TRAFFIC IMPACT ASSESSMENT (TIA)

Proposed Seniors Living and Registered Club Development Forestville RSL Club

Reference: 24.186r01v06
Date: May 2025

8. RESPONSE TO REQUESTS FOR INFORMATION

Drawing Title
Ground Floor
10.5m Heavy Rigid Vehicle (HRV)
Left: Entry down to the basement from to the street
Right: Egress from the ramp and turning out of the basement to the street

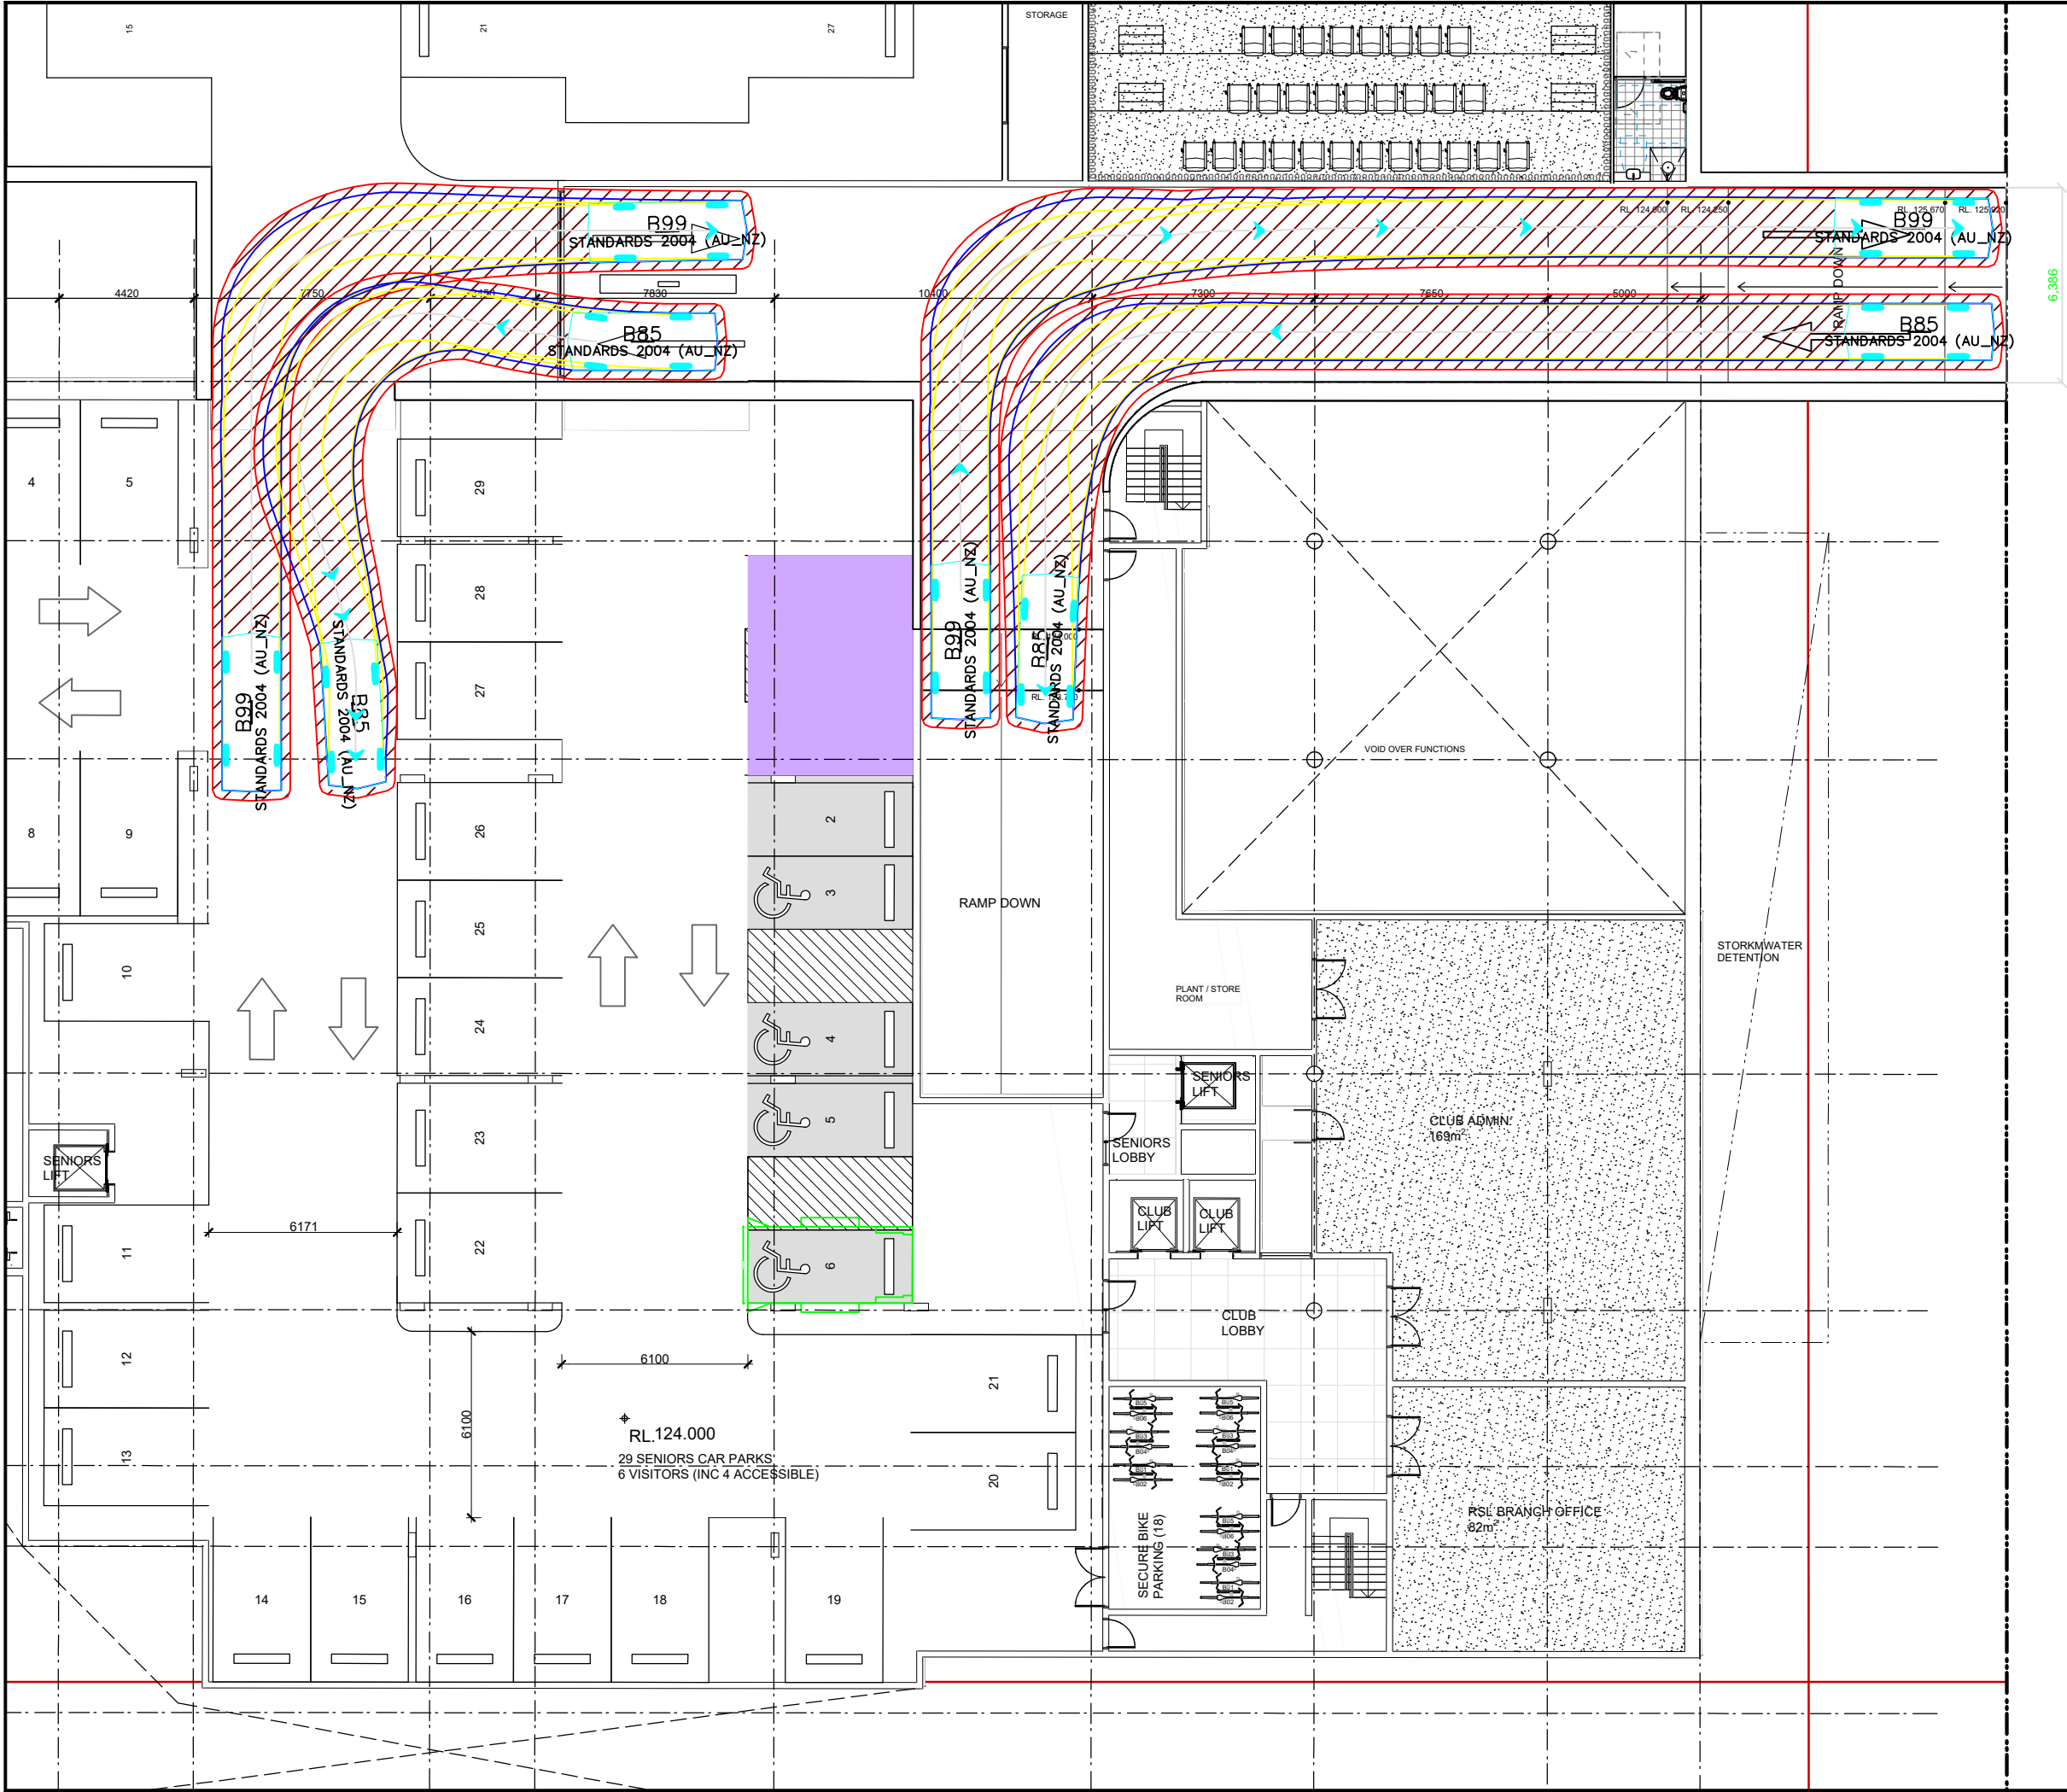
"A proposed 4.2m wide entry only driveway and 6.2m wide egress only driveway is provided for access to the loading dock, at grade drop off and parking area which have been designed to accommodate the largest service vehicle required to access the subject site being an 8.8m MRV. The 4.1m access ramp to the basement loading dock does not provide sufficient width for trucks to pass. The TIA notes that an Operational Management Plan (OMP) for the club will consider loading dock management, however a traffic signal system must be provided to manage the movement of trucks entering and entering the loading area. The TIA has provided swept paths for a 8.8m medium rigid vehicles (MRV). Waste Services have advised waste trucks are heavy rigid vehicles and typically 10.5m long, 2.5m wide, service height 4.5m, travel height 3.7m, and the loading dock should be designed to cater for the largest vehicle type. Consideration and provisions should also be made with respect to how goods and services will be provided to cater for the residents of the senior housing. A Loading Bay (minimum Small Rigid Vehicle access) should be provided for servicing, removalists and bulky goods deliveries.

It is preferable to provide separate accesses to loading facilities and car park areas. The access driveway to the loading dock should provide two-way access for safe and convenient access to/from Melwood Avenue. The recommended relocation of the main access to the centre of the site will enable the driveway to be widened accordingly. The current egress driveway can therefore be reduced in width and changed to entry only for the Porte Cochere access and at-grade car park which includes an Ambulance Bay. The TIA provides swept paths for an ambulance reversing into the bay and entering in a forward direction. The Architectural Plans shows a kerbed landscaped area at the back of the Ambulance Bay which should be removed as it obstructs the rear loading of the ambulance".

A separate combined entry/exit accessway to the loading area is provided which has a width of six (6) metres and accommodates two-way flow, with sufficient passing opportunities at the entry, towards the loading/service area which will be used by the club and residents for servicing subject to a future Operational Management Plan. As discussed in **Section 5.6** and **Section 7.1** the proposed access is designed to accommodate a 10.5m long heavy rigid waste collection vehicle which is the largest design vehicle that would be entering the loading and servicing area. With respect to residential waste collection, as per Council's waste teams'
